INFN
RICH Detector for Hall B

MECHANICAL REVIEW
REPORT

BACKGROUND OVERVIEW & COMMITTEE CHARGE

Date: June 20, 2014

Figure 1: View Showing Clearance Between RICH, R3, and FTOF

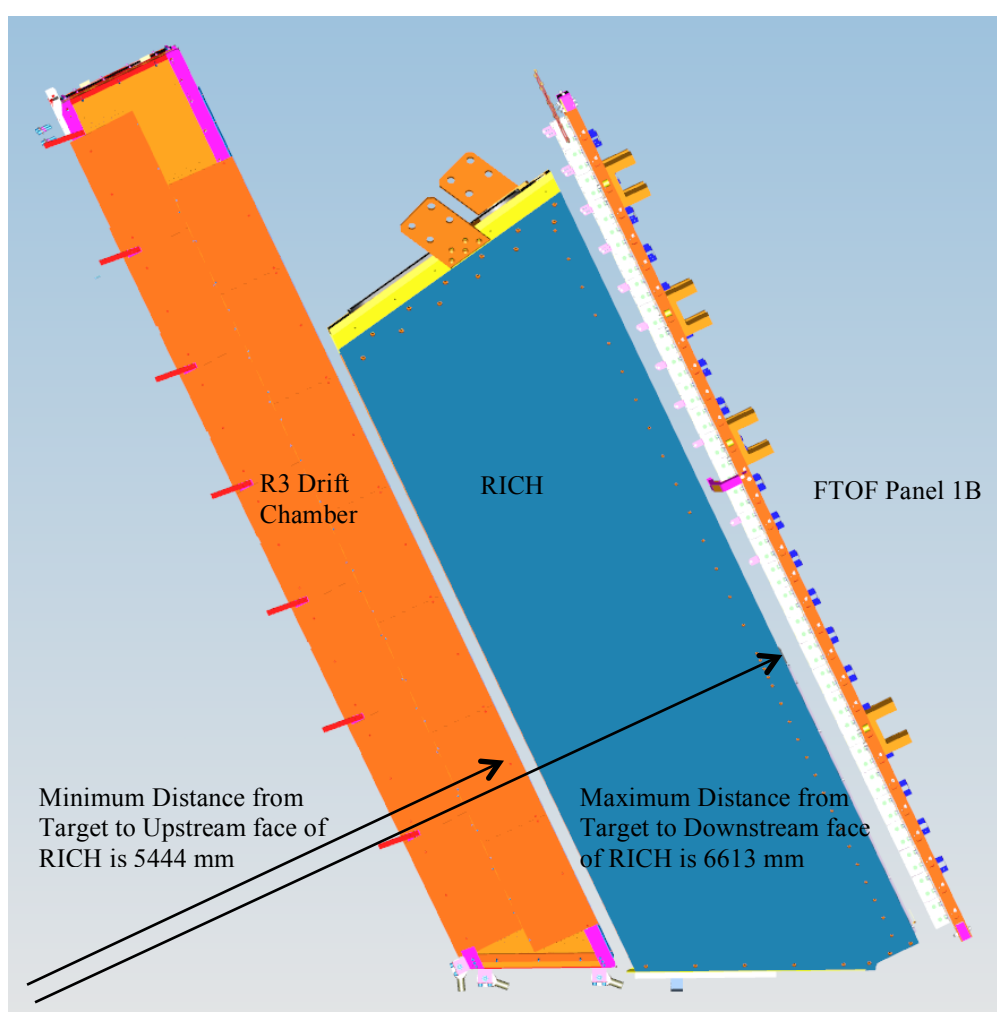
1. The INFN team provided a 3D model of the RICH detector and the LTCC in June 2014. The model was placed in the Hall model at the final LTCC location. As shown in Figure 1, the minimum distance from the target to the most upstream portion of the RICH detector is 5444 mm. The maximum distance from the target to the most downstream portion of the RICH detector is 6613 mm.

Figure 4: Pictures of the FTOF detector showing the encumbrance of the cables routing and holders: the cable bundles (highlighted in black) seem not accounted for in the 3D model. The L metallic holders (highlighted in blue) is assumed to be the maximum FTOF protrusion.

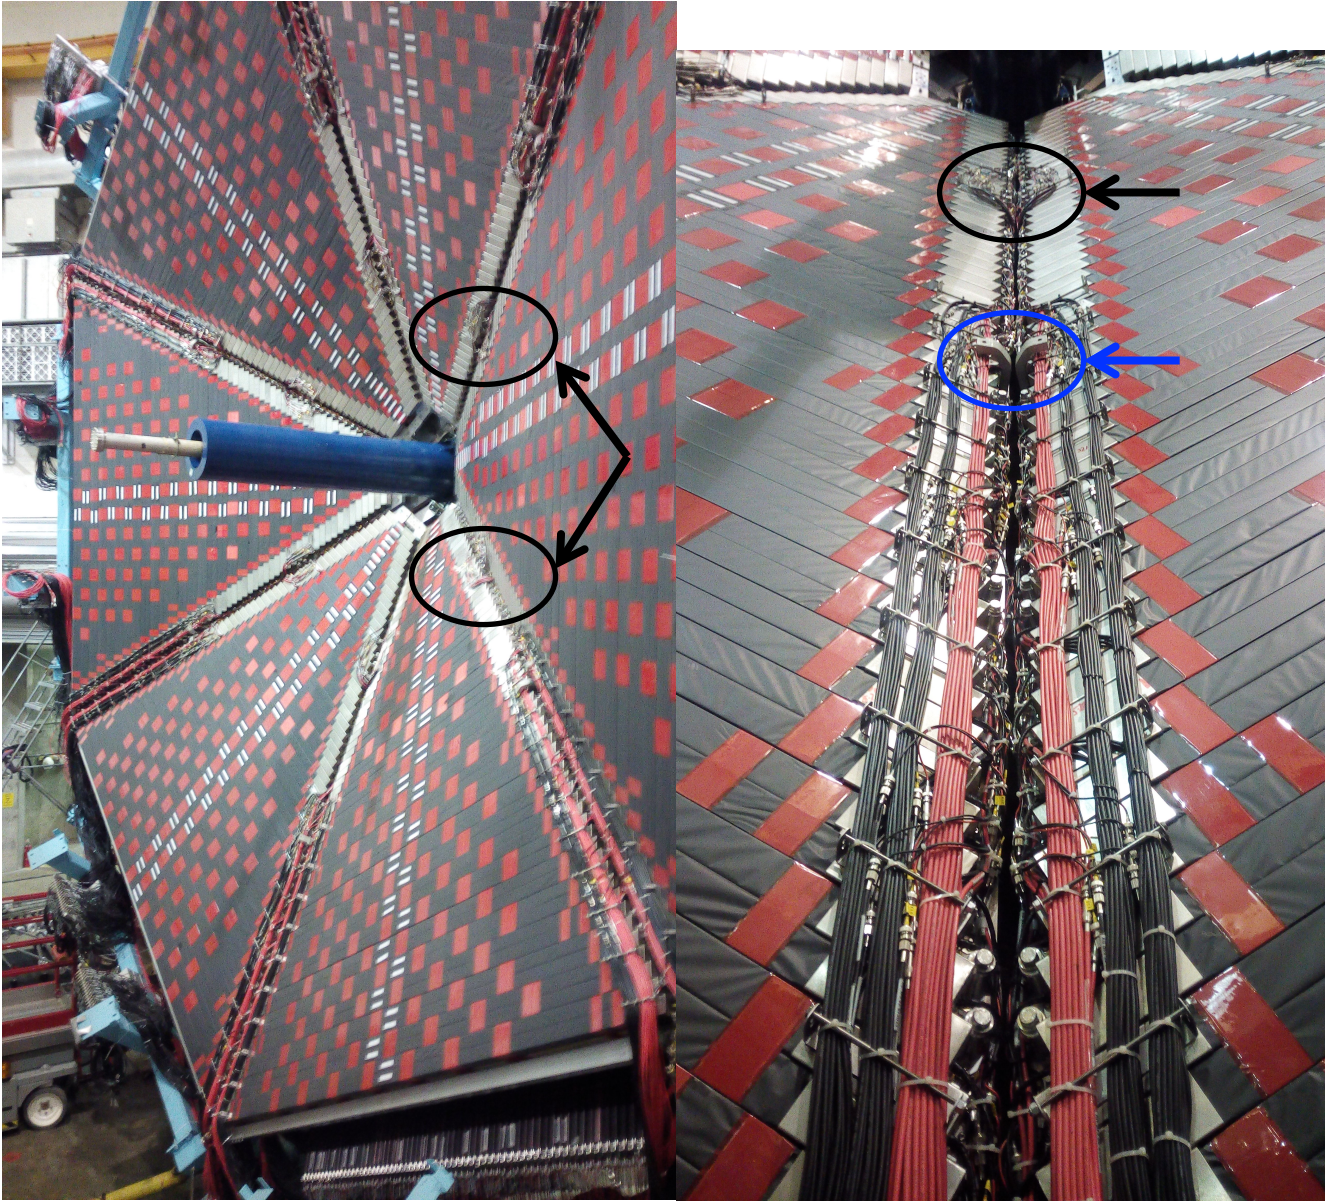
- May you verify the current positions of RICH and other detectors reported in Figure 3? Are the distances correct and acceptable?
- We assumed the maximum FTOF protrusion is the L metallic elements highlighted (in blue) in Figure 4. Is it correct?
- Is there any conflict between the cable bundles highlighted (in black) in Figure 4 and the possible 1-inch RICH extension downstream the electronic box for the insertion of the suggested insulation panel to reduce the heat load on the FTOF?

A large scale and high-resolution version of Figure 3 will be made available together with this document. The details in Figure 3 show the minimum distance between the RICH detector and the other CLAS12 detectors (DC and FTOF). Note that the details of the FTOF cable routing and holders visible in Figure 4 are fully accounted for in the 3D model except for the cable bundle highlighted in black.

Figure 5: Matching of the right RICH holder and the forward carriage stirrup

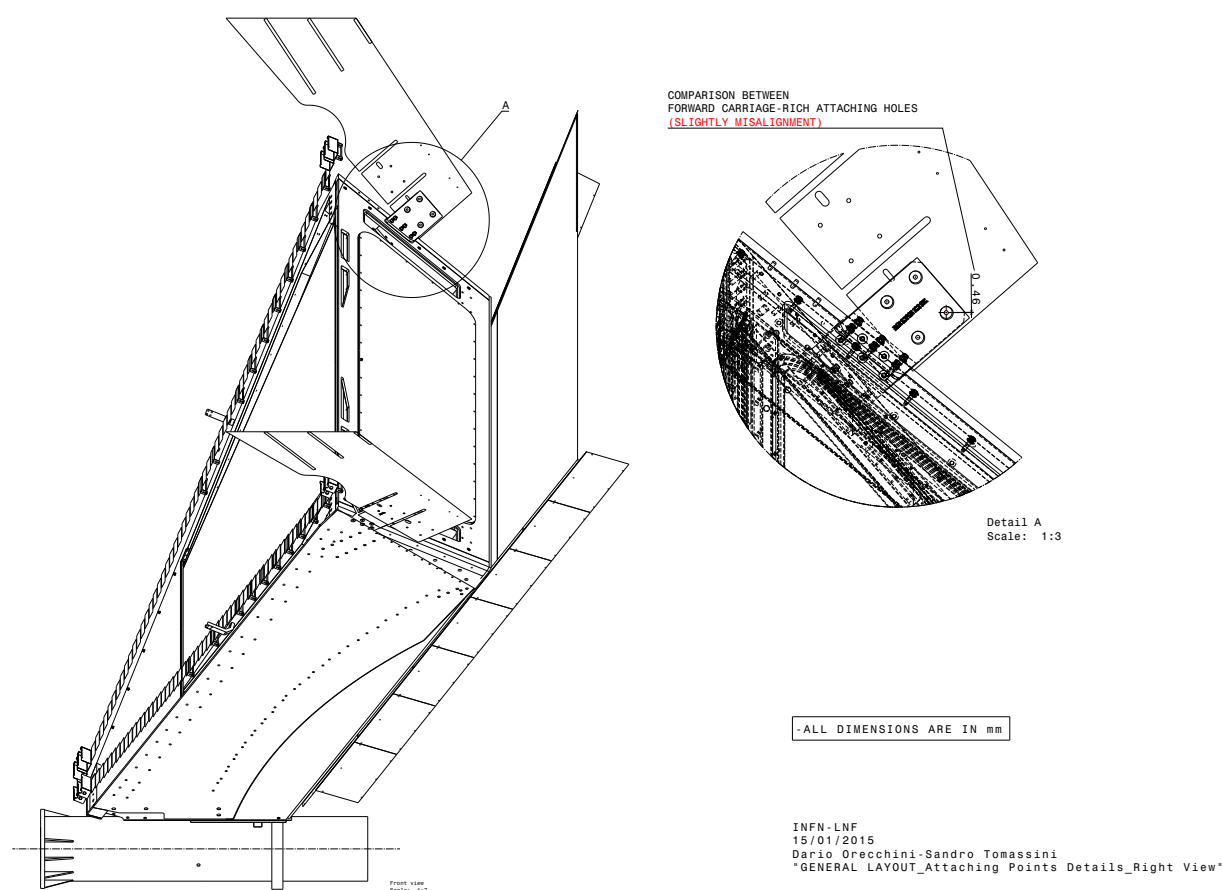
There RICH holders match the forward carriage stirrups as shown in Figure 5 and 6. The RICH central holder and the beam-pipe collar holes match, as shown in Figure 7. The RICH central holder perfectly overlaps the position of the LTCC one but there is a longitudinal displacement of about 3 cm with respect the beam-pipe collar, as shown in Figure 8.

Figure 8: Shift along the beam line (z) of the beam-pipe collar versus the central RICH holder

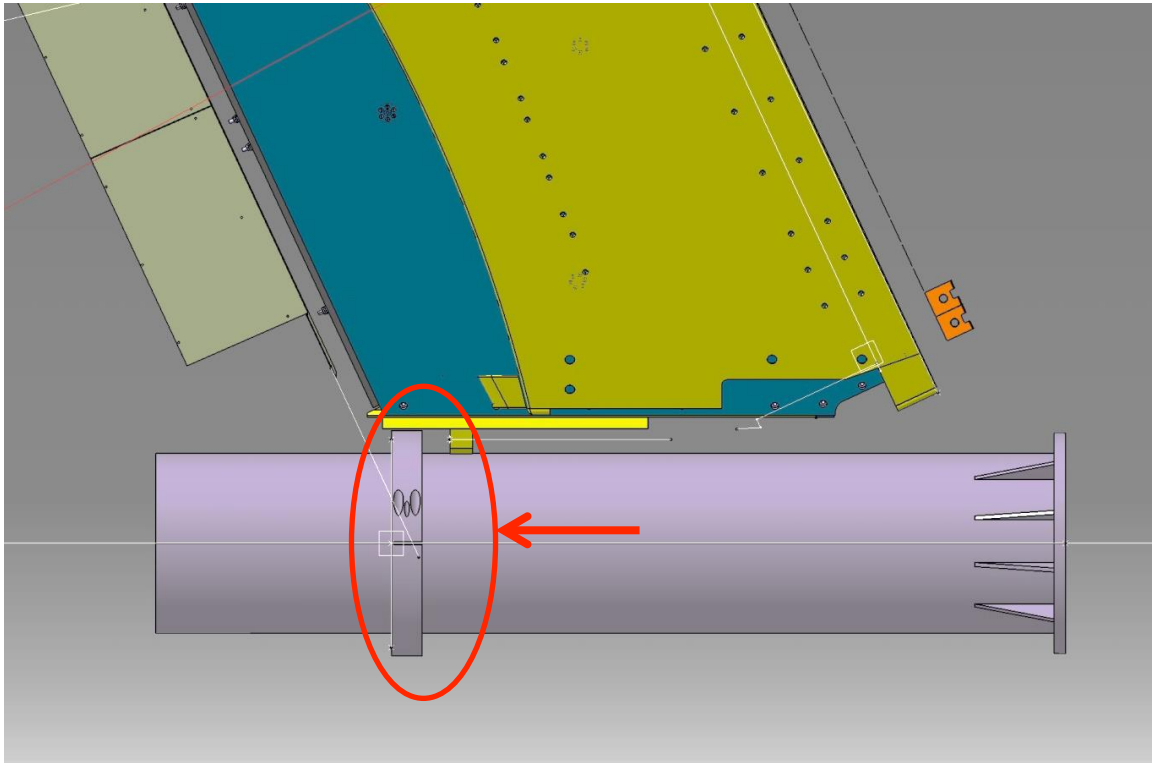
- D. Is the beam-pipe collar (highlighted in Figure 8) movable in z or should the RICH (LTCC) central stirrup be modified to match the fixed z position of the beam-pipe collar?
- E. Is there any recommended material for the RICH holders (our suggestion is AISI-316L)?
- F. Is any of the RICH parts required to be made of non-magnetic material?

Figure 10: Exploded view of the real scale cooling prototype (halved module) and the relative panels under construction at Frascati Laboratory.

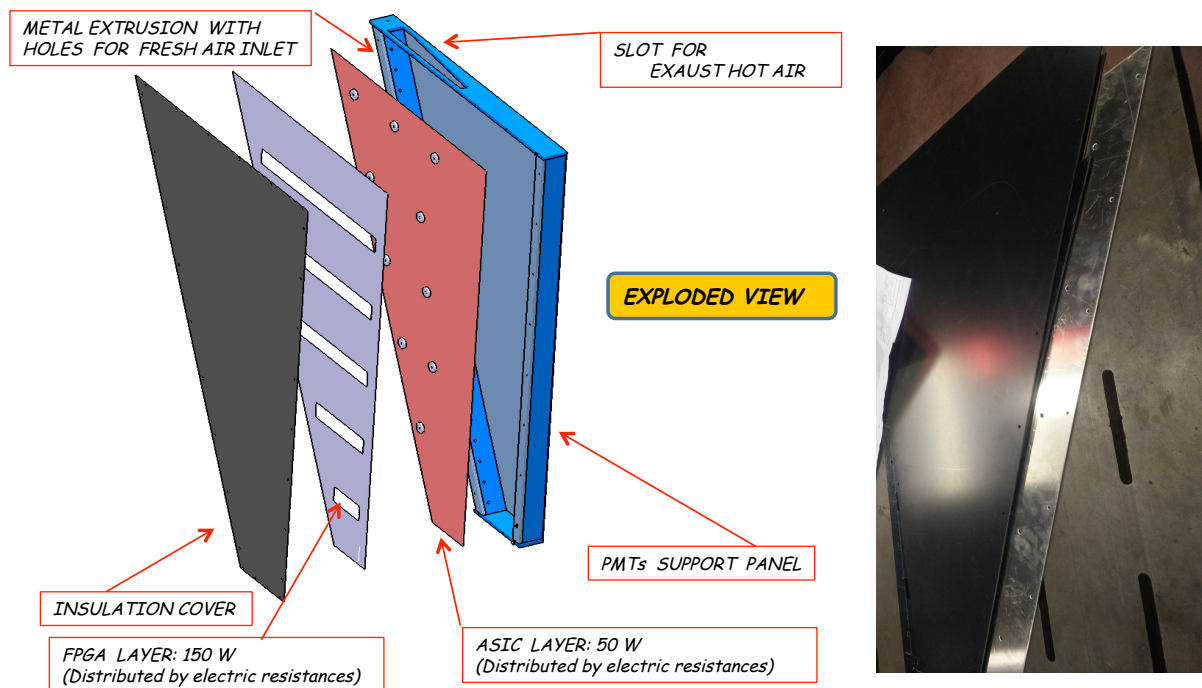
1. The RICH detector group should show by analysis that the steady state temperature of the FTOF panel 1B will not exceed 30C. It is acceptable to extend the RICH detector 1 inch downstream at the electronics box location to install insulation to reduce the heat load on the FTOF. The insulation must not interfere with the FTOF panel 1B cables. Contact Joe Guerra for dimensions of the cable locations if insulation is used.

A solution is under study to place insulation inside the electronic box and/or outside the box itself without interfering with the FTOF cables and mechanical structures.

A real-scale test setup is under construction in Frascati Laboratory to measure the real field temperature inside and outside the box, validate the FEM analysis and evaluate the efficiency of the cooling system, see Figure 10 and 12.

Figure 13: Mechanical deformation of the RICH structure with loads and an internal pressure of 1 mbar

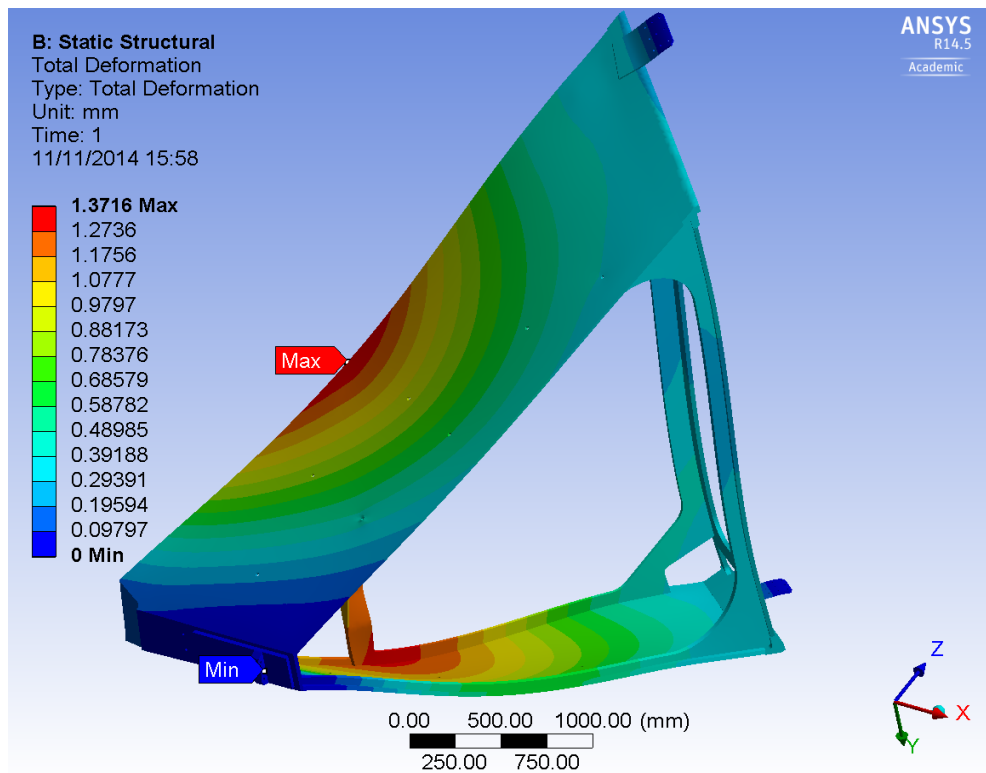
1. The internal pressure of the RICH detector from the N₂ dry gas system shall be included in the FEA analysis of the detector. The statement: “pressure: wanted levels of ~30-40 mbar are not expected to affect mechanics significantly” must be confirmed via analysis.

The internal pressure of the RICH, due to the purging gas, has been reduced as much as possible, to the level of about 1 mbar, in order to maintain the effectiveness of the purging system and reduce the load on the structures itself.

FEM analysis of the RICH module and panels has been performed with two different level of pressure (1 mbar and 0.5 mbar).

The stress and strain level on the structure results acceptable. With an overpressure of 1 mbar acting on the external surfaces, the maximum deformation of the RICH structure is 1.4 mm, with an increase of about 10% with respect to the case of 0 mbar internal pressure (and only weight accounted for), see Figure 13. At the same overpressure the entrance panels gets a maximum displacement of few tens of mm, see Figure 14.

Figure 15: Conceptual design of the RICH gas system reviewed by George Jacobs.

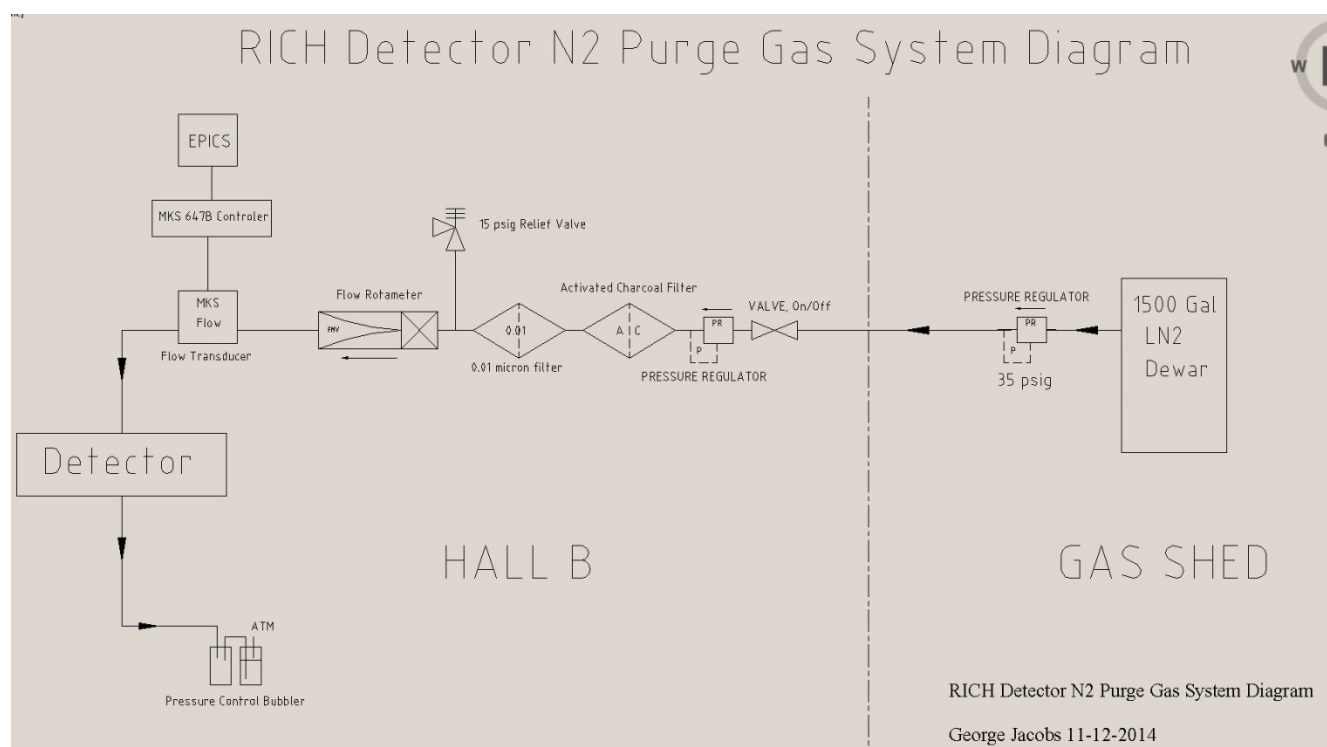
2. A properly sized relief valve will be required after the pressure regulator, preferably a properly sized 15 psig relief to eliminate pressure system requirements downstream. The pressure regulator used must be for pure gas and have the proper outlet pressure range of 0-15psig (0-1 bar).
3. The controller for the N₂ system shall be an Allen Bradley [CompactLogix](#) to match the other Hall B gas system controllers for ease of programming and maintenance.
4. The dry nitrogen volume, all be it relatively small, shall have an approved oxygen deficiency hazard safety review per JLab ODH guidance.
5. The final design of the dry nitrogen piping and ventilation systems shall be reviewed by a JLab engineering subject matter expert(s).

The RICH group has started a collaboration with George Jacobs to ensure the RICH gas system conforms to the Hall-B regulation and safety and fulfills the above recommendations.

In November, Frascati engineers had a first meeting with George Jacobs to review the conceptual design of the RICH N₂ purge gas system, discuss its compatibility with the Hall-B nitrogen supply line and identify basic elements, i.e. pressure regulator, relief valve, rotameter, bubbler and black nylon lines, see Figure 15.
